Tub - door gasket deformation or damage. Upper basket rail collision with tub – door gasket.

Rail collision with gasket.

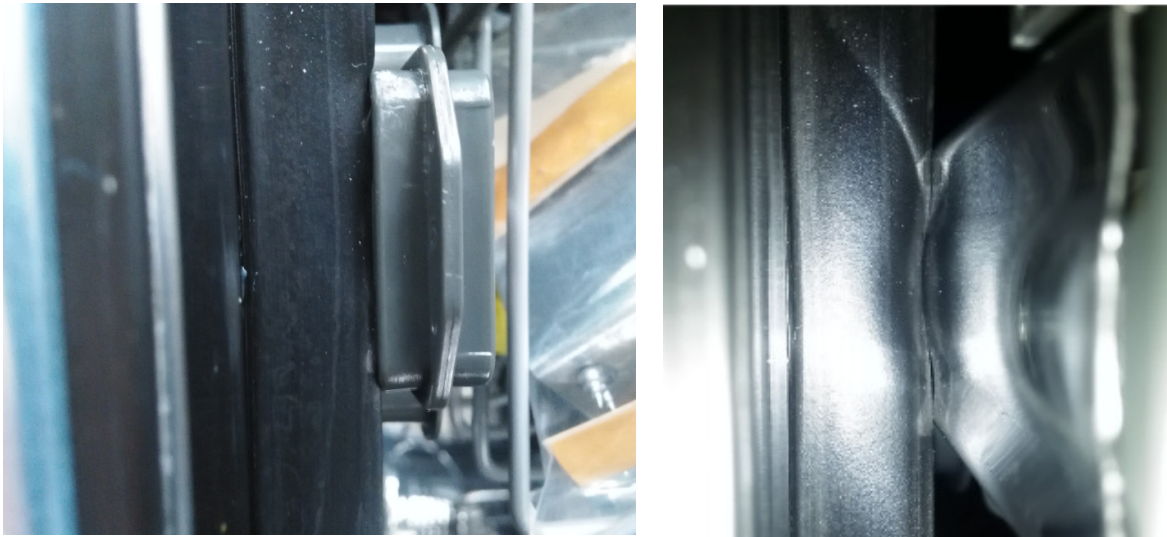
Upper basket rail collides with door – tub gasket. Gasket deforms or is damaged. Gasket can get detached from tub. Problem can occur in all Domodossola dishwashers with serial number up to 702xxxxx.

Change upper basket rails and tub–door gasket. New upper basket rail has improved shape to avoid gasket damage.
